Proposed Revisions to a Standard Plans Index

Originator:	Turley, Joshua	Index Number:	455-124
Date:	8/21/2024	Sheet Number(s):	2
E-mail:	Joshua.Turley@dot.state.fl.us	Index Title:	24" SQUARE CFRP & SS PRESTRESSED CONCRETE PILE

24" SQUARE CFRP & SS PRESTRESSED
CONCRETE PILE

STRAND PATTERN

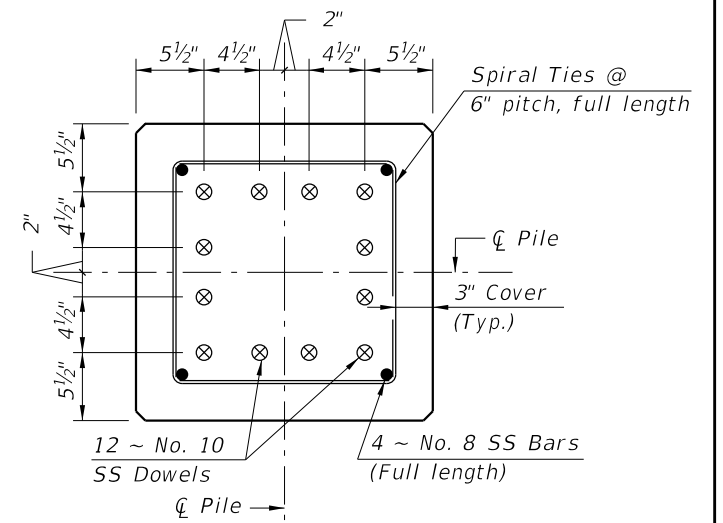
Sheet 2: Adjusted Strand Pattern diameter decimal places

CHANGED TO: 0.520"

CHANGED TO: 0.620"

This is a more accurate representation of the nominal diameter driven by the fact that the strands are fabricated in millimeters not inches.

STRAND PATTERN

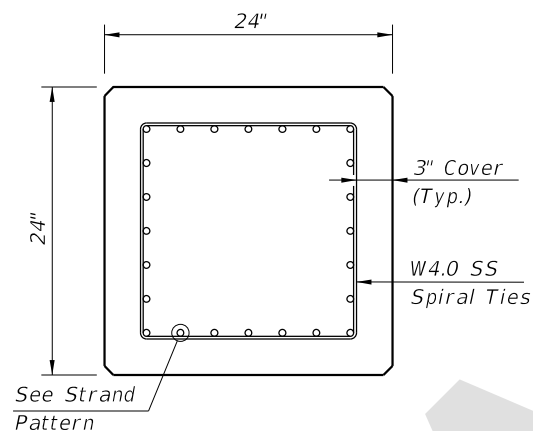
28 ~ 0.52" Ø, HSSS at 26 kips
20 ~ 0.62" Ø, HSSS at 35 kips
